HISTORIC AND DESIGN REVIEW COMMISSION

HDRC CASE NO: 2024-159
ADDRESS: 222 CAMARGO
LEGAL DESCRIPTION: NCB 924 BLK 5 LOT 5
ZONING: RM-4 CD, H
CITY COUNCIL DIST.: 1
DISTRICT: Lavaca Historic District
APPLICANT: Daniel Cruz/Design Coop
OWNER: Joshua Vess
TYPE OF WORK: Two-story rear addition, fenestration changes
APPLICATION RECEIVED: April 10, 2024
60-DAY REVIEW: June 9, 2024
CASE MANAGER: Jessica Anderson

The applicant requests a Certificate of Appropriateness approval to:

1. Replace one window on the first story of the existing rear addition with French doors with a transom.
2. Construct a two-story rear addition with a rear deck.

A2.0

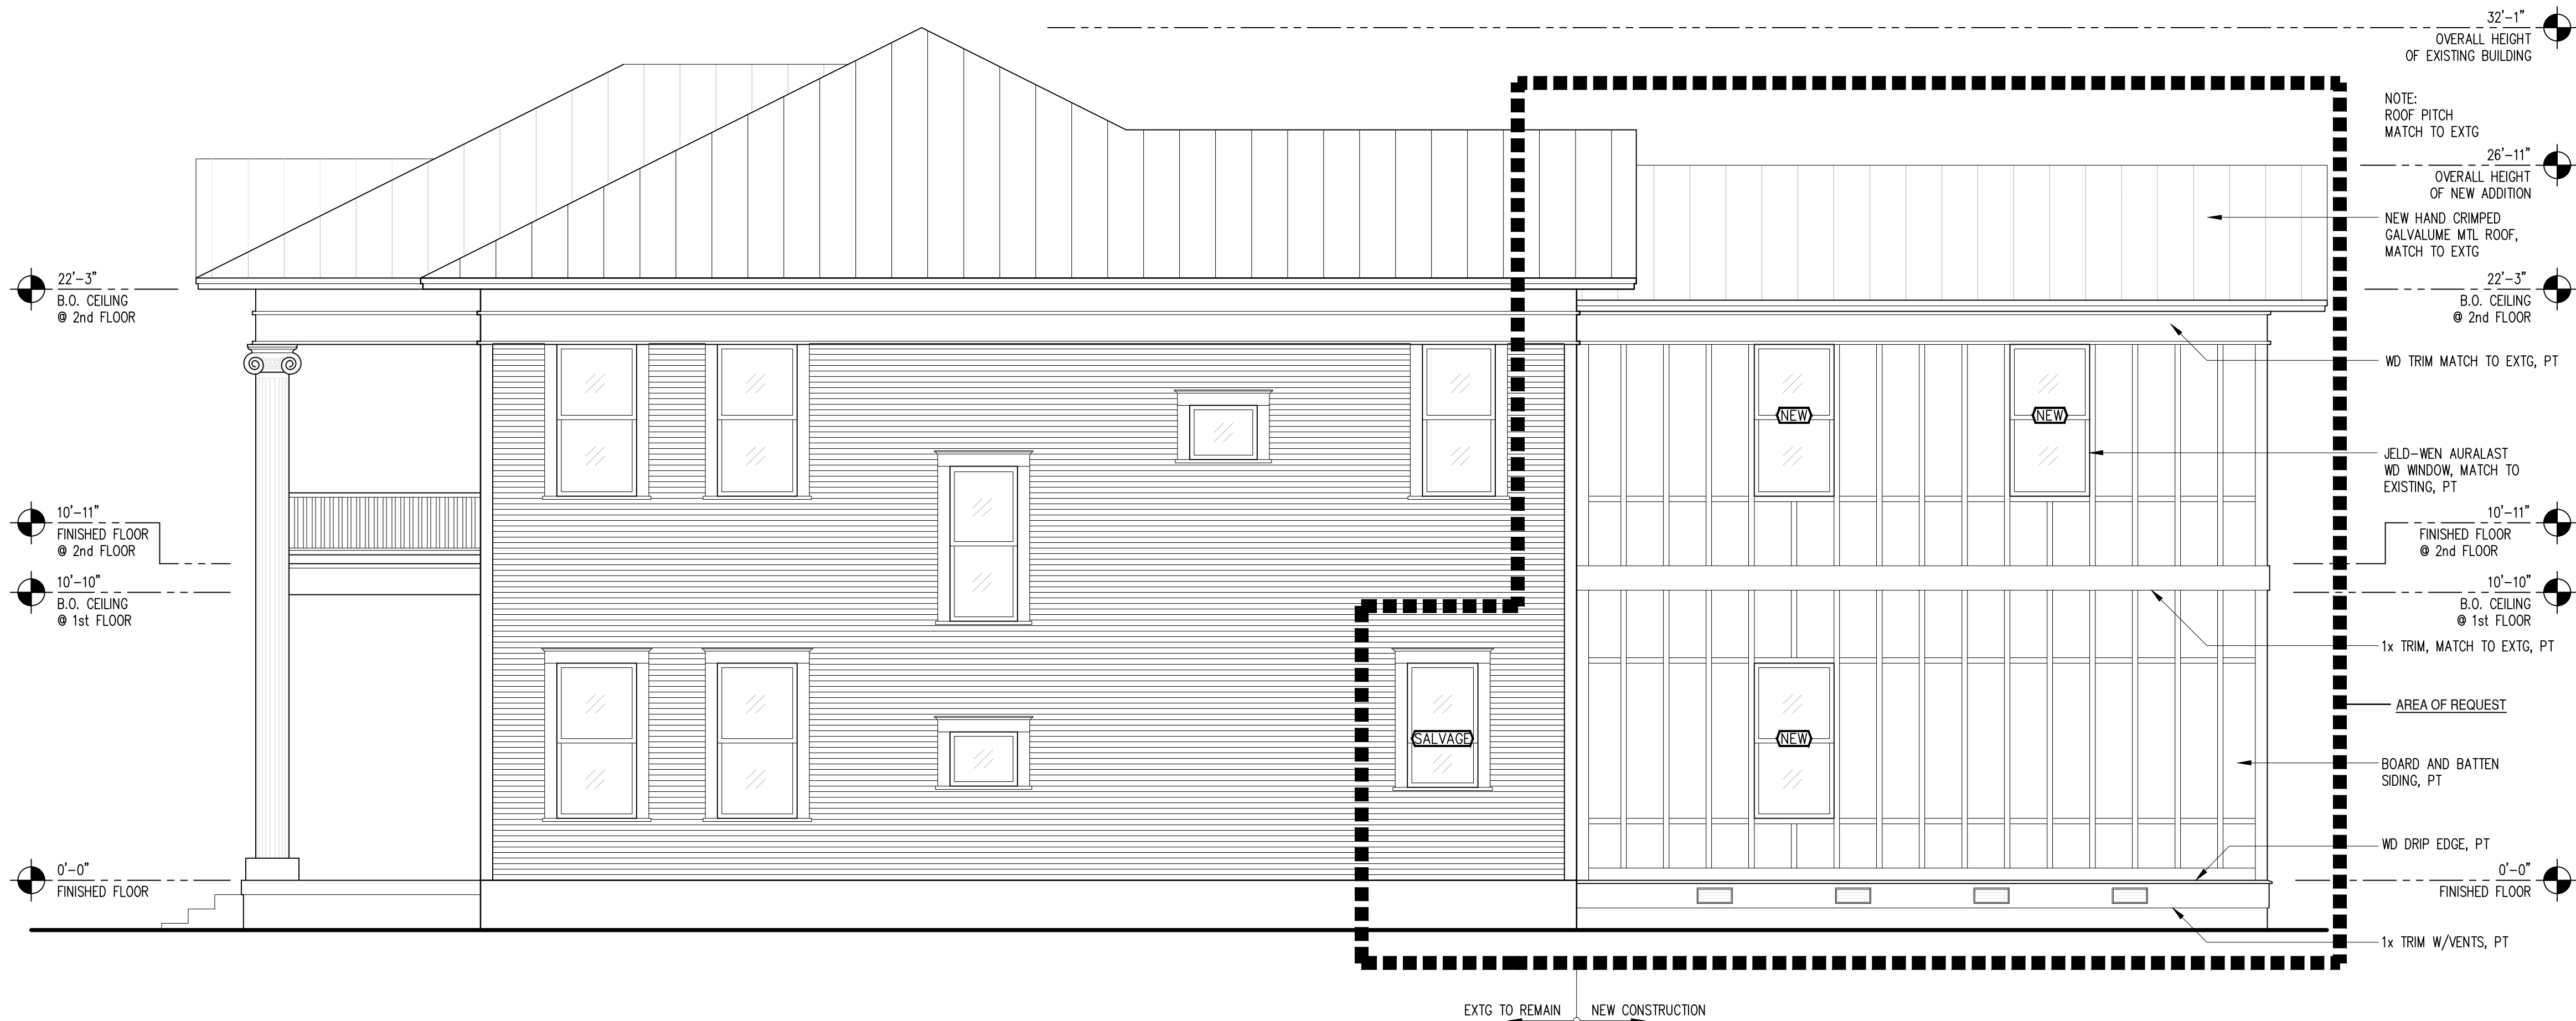
- f. **WINDOWS:** The applicant proposes to salvage and reuse one existing one-over-one wood window, and introduce new one-over-one wood windows to match existing. Standard Specifications for Windows in Additions and New Construction stipulate that new windows on additions should relate to the windows of the primary historic structure in terms of materiality and overall appearance. Staff finds the proposed window product does not conform to guidelines. The applicant must submit manufacturer's specifications and a cut sheet for a new window product that conforms to Standard Specifications for Windows in Additions and New Construction prior to the issuance of a Certificate of Appropriateness. Additionally, the applicant should introduce windows on the second floor of the southwest elevation.

- g. **DOORS:** The applicant proposes one eight-lite door with transom and two sets of eight-lite French doors with transoms for the addition. Existing doors on the non-primary elevations are full-lite doors. Historic Design Guidelines for Additions 3.A.i states that additions should include materials that match in type, color, and texture and include an offset or reveal to distinguish the addition from the historic structure whenever possible. Any new materials introduced to the site as a result of an addition must be compatible with the architectural style and materials of the original structure. Staff finds the proposed doors appropriate, but that they should be true divided lites.

- i. That the applicant introduces windows on the second floor of the southwest elevation, as noted in finding f.
- ii. That the applicant submits manufacturer's specifications and a cut sheet for a new window product that conforms to Standard Specifications for Windows in Additions and New Construction prior to the issuance of a Certificate of Appropriateness, as noted in finding f.
- iii. That the applicant proposes doors with true divided lites for the addition, as noted in finding g.
